Office Action Summary

10/821,784

VIELHABER ET AL.

DETAILED ACTION

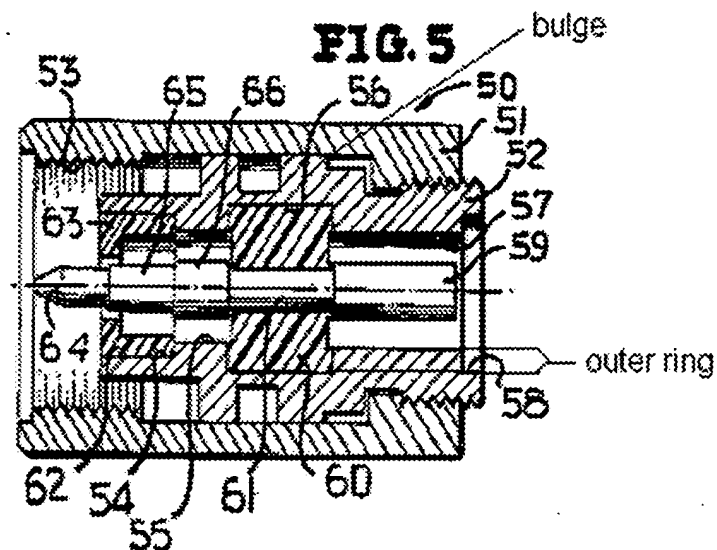
Regarding claims 2 and 3, Banning discloses the outer conductive sleeve formed with at least one outwardly extending ring-shaped bulge (see following figure). Please note that the method of forming a device is not germane to the issue of patentability of the device itself. Therefore, this limitation has been given little patentable weight. Please note that the claim does not present any structural difference from the prior art.

Regarding claim 4, Banning discloses the insulator formed with at least one outer ring (see following figure), and the bulge being formed against the ring and shaped thereby.
